**Initial Study/Mitigated Negative Declaration  
Trimble and Agnews Municipal Groundwater Wells  
File No. ER20-015**

**RESPONSES TO PUBLIC COMMENTS AND  
TEXT CHANGES**

June 2021

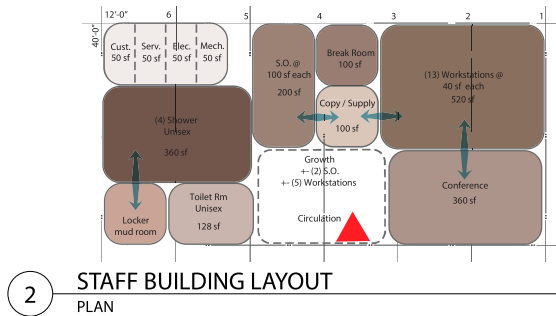
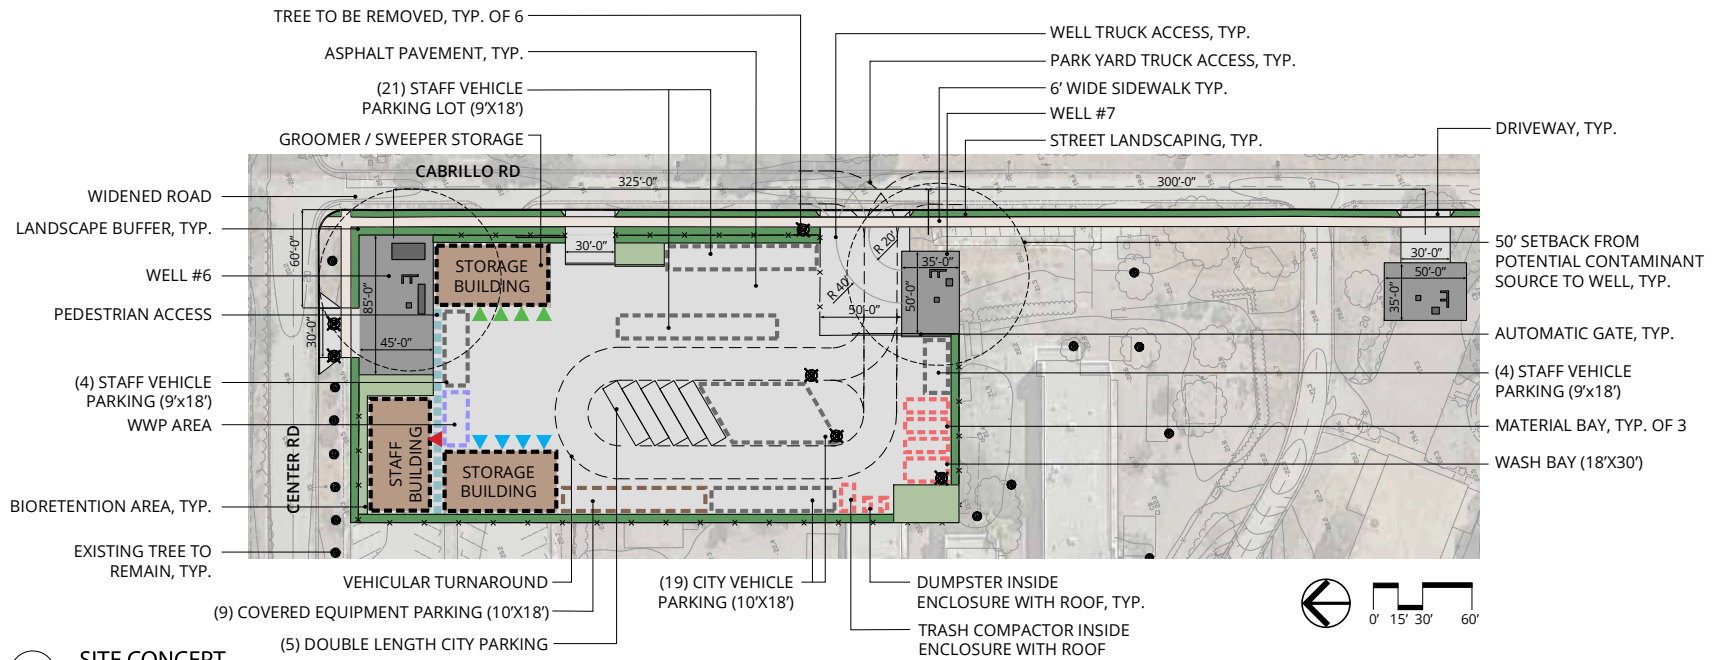
2. When coordinating with Muni Water and developing the conceptual plan, the plan was to have Well #6 be the main site "larger site" while the two remaining wells would be of much smaller footprint (only including the well head, piping/catch basin, and enough room for one maintenance vehicle. The study seems to imply that all 3 well sites could be the same size and include the same components. Figure 3-5 only represents the main site not each well site.

- a. Page 3-9 states: Above ground facilities would be installed within the maximum 10,000- square foot (100 feet by 100 feet) footprint for each well site. This footprint would include the motor control center, above ground piping and control valves, emergency backup generator, transformer and power plant appurtenances, storm drainage utilities, and control and communication equipment. Figure 3-5 provides an illustrative depiction of the above ground components layout for the well.

The draft concept plan that was attached to the PRNS comment letter on the IS/MND has been referenced above, in Section 3.2.1, Master Response, *Impacts on Agnews East Park Design, and on the River Oaks Parkway Neighborhood*. The larger footprints that are analyzed in the IS/MND represent a maximum footprint, as noted by the IS/MND and this comment, and as such, represent a worst-case scenario. Well NSJ #6 alone is depicted in IS/MND Figure 3-5 because it includes the single, standby emergency generator that is intended to be utilized for all three wells. The plan for the proposed park and the plans for the Project are still conceptual, and the well site footprints may be reduced during final design. Municipal Water will continue to work with PRNS on a collaborative solution.

Dresden-13

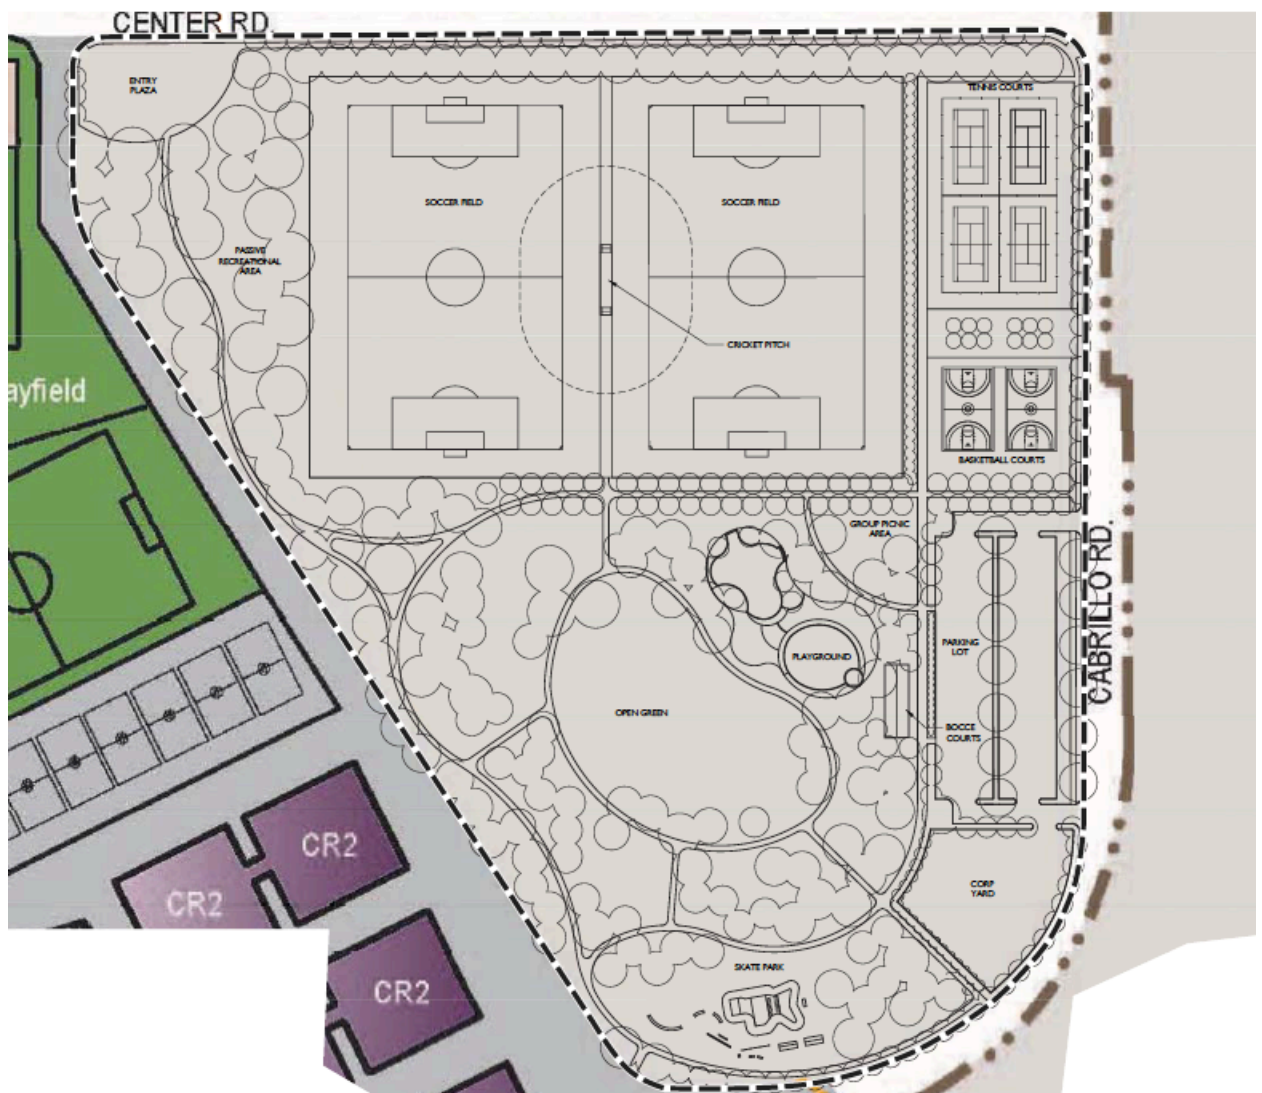
9. The City set aside money from the Parks Bond of 2000 for a soccer complex. Challenges ensued and a property at Coleman avenue was subsequently sold. Agnews was identified as the potential home of future soccer fields is the staff analysis of the land sale. How does the diversion of these 1.2 acres thwart that council direction? It is not discussed in the IS/MND.

This comment refers to previous City decisions regarding potential future uses of Agnews. This comment does not identify any inadequacy with the CEQA analysis, new significant impacts, or additional mitigation measures than those analyzed and disclosed in the IS/MND and associated appendices. Therefore, no additional response is required. See also Section 3.2.1, Master Response, *Impacts on Agnews East Park Design, and on the River Oaks Parkway Neighborhood*.

Concept Map from 2014 Agnews East Addendum to North San Jose EIR

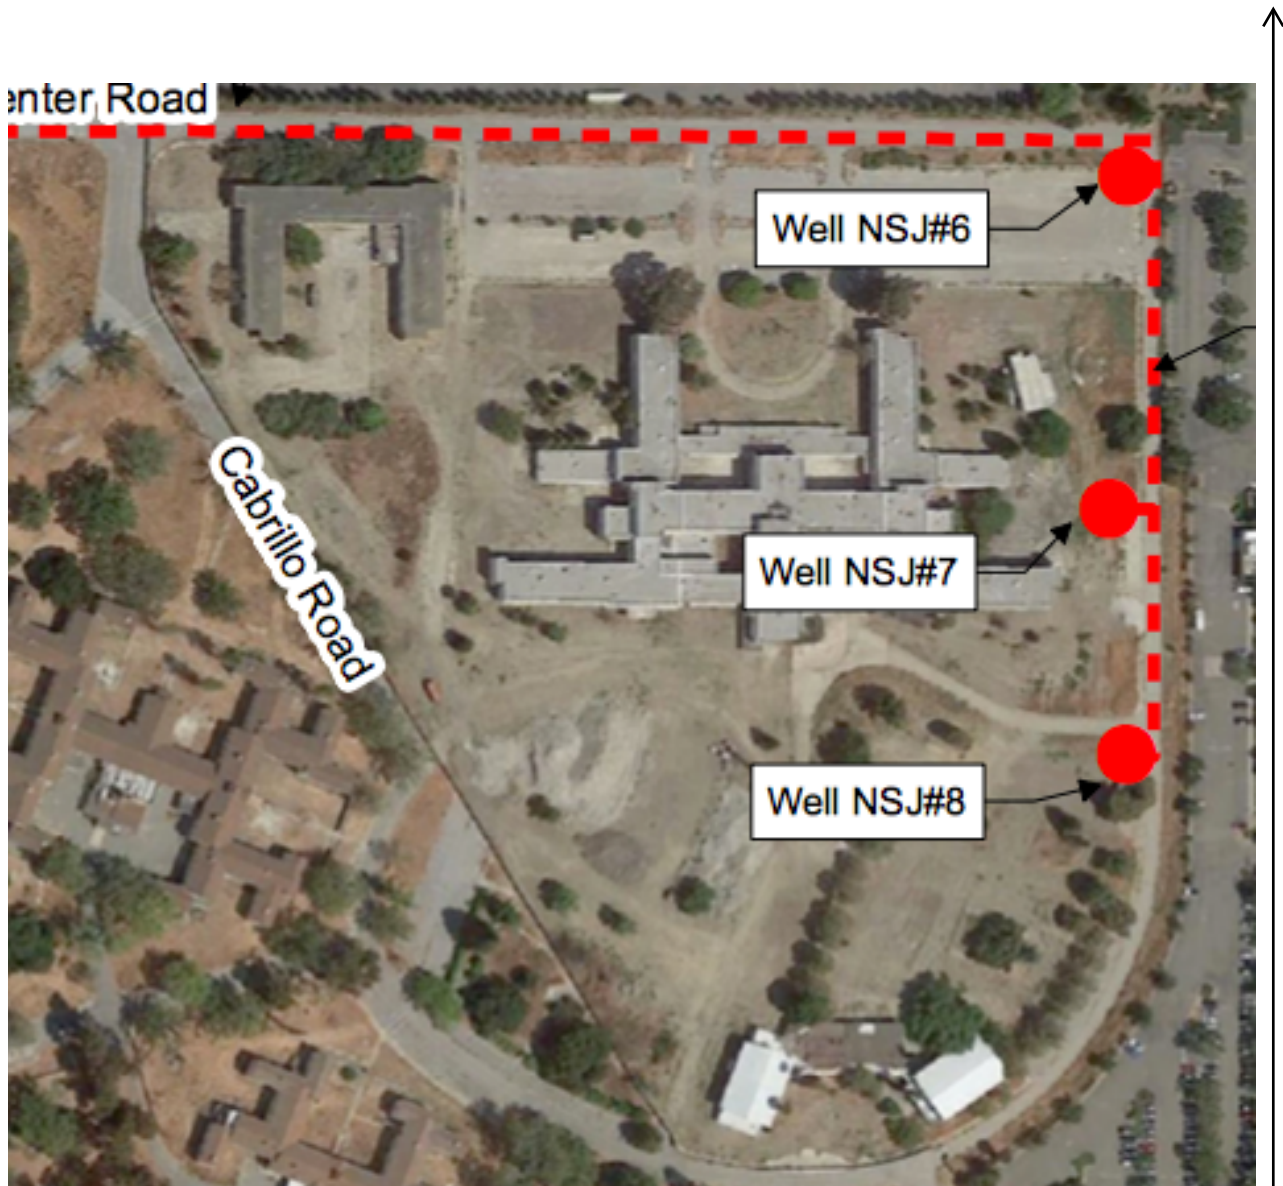
11. The Recreation section of the IS/MND does not discuss how the three buildings will impede the future development of the park far beyond the acreage taken for the wells. The three well-sites are dispersed along the boundary of the park, penetrating 100 feet to the east along with a roadway of a minimum of 20 beyond that. The large building jut out into the park and make for blind spots that are hard to police and patrol. The buildings violate park design standards that are given to developers for Turnkey operations (no blind spots!) In the concept maps of the Agnews park approved in the Agnews East Park addendum to the North San Jose Plan, a concept map showing two soccer fields, tennis courts, and other active sport amenities was published to help community members to understand how the park might be developed. The IS/MND does not reveal this concept map nor discuss how these large buildings will eliminate multiple amenities desired by the community. Further, the map that is presented has circles instead of rectangles to scale and does not show the road bed. The IS/MND did not reveal the significant impact that their project will have on the final design of the park. Three maps follow. The concept map from 2014, the IS/MND map with circles, and the concept map annotated with 10, 000 square foot buildings.

Several concept plans have been developed for a proposed park at the Agnew site. However, a park design has not yet been developed or finalized, and a park design has not yet been approved

or funded. Please see Section 3.2.1, Master Response, *Impacts on Agnews East Park Design, and on the River Oaks Parkway Neighborhood*
